Product/Process Change Notice (PCN)

<p>PCN Number: PCN_UtPoE++_UtPOETI MID_20250313</p> <p>Affected Series: WE-PoE++</p> <p>Affected Part Number: 750313355</p> <p>PCN Date: 2024-12-13 (YYYY-MM-DD)</p> <p>Effective Date: 2025-03-13 (YYYY-MM-DD)</p>	<p>Change Category:</p> <p><input type="checkbox"/> Equipment/Location <input checked="" type="checkbox"/> General Data <input type="checkbox"/> Material <input type="checkbox"/> Process <input type="checkbox"/> Product Design <input type="checkbox"/> Shipping/Packaging <input type="checkbox"/> Supplier <input type="checkbox"/> Software</p>
<p>Contact: Product Management</p> <p>Phone: +49 (0) 7942 - 945 5001</p> <p>Fax: +49 (0) 7942 - 945 5179</p> <p>E-Mail: pcn.eisos@we-online.com</p>	<p>Datasheet Change:</p> <p><input checked="" type="checkbox"/> Yes <input type="checkbox"/> No</p> <p>Attachment:</p> <p><input type="checkbox"/> Yes <input checked="" type="checkbox"/> No</p>

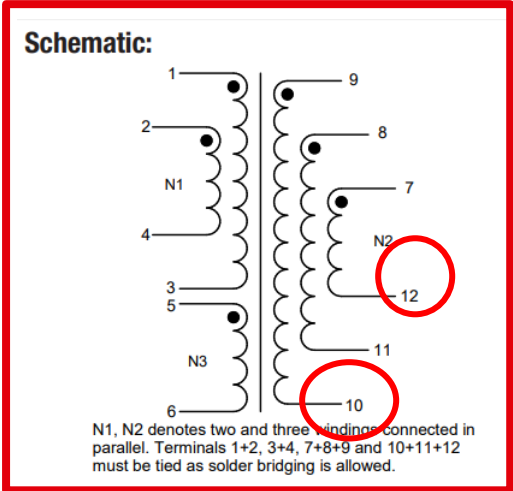
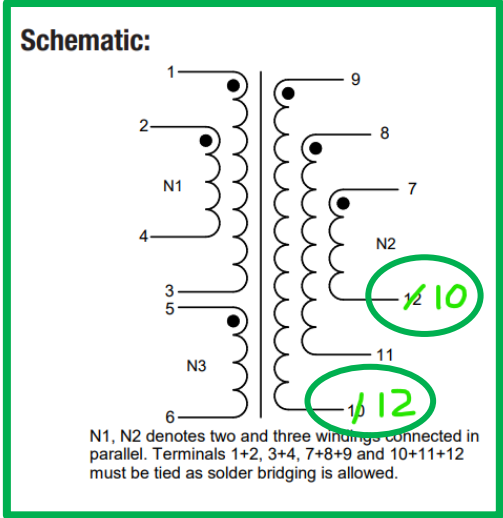
Because of a database mismatch, Würth Elektronik eiSos will correct pin layout on the datasheet's schematic. This is a datasheet correction only. There will be no change in form, fit, function, quality or reliability of the product.

DETAILS OF CHANGE:	
Schematic Pin Numbering	
Before Change	After Change
<div style="border: 2px solid red; padding: 10px;"> <p>Schematic:</p>  <p>N1, N2 denotes two and three windings connected in parallel. Terminals 1+2, 3+4, 7+8+9 and 10+11+12 must be tied as solder bridging is allowed.</p> </div> <p style="color: red;">Secondary winding lists incorrect pin numbering of 7-12 and 9-10</p>	<div style="border: 2px solid green; padding: 10px;"> <p>Schematic:</p>  <p>N1, N2 denotes two and three windings connected in parallel. Terminals 1+2, 3+4, 7+8+9 and 10+11+12 must be tied as solder bridging is allowed.</p> </div> <p style="color: green;">Secondary winding lists correct pin numbering of 7-10 and 9-12</p>
RELIABILITY / QUALIFICATION OF CHANGE:	
<p>There will be no change of the product, therefore no additional reliability or qualification testing was performed.</p>
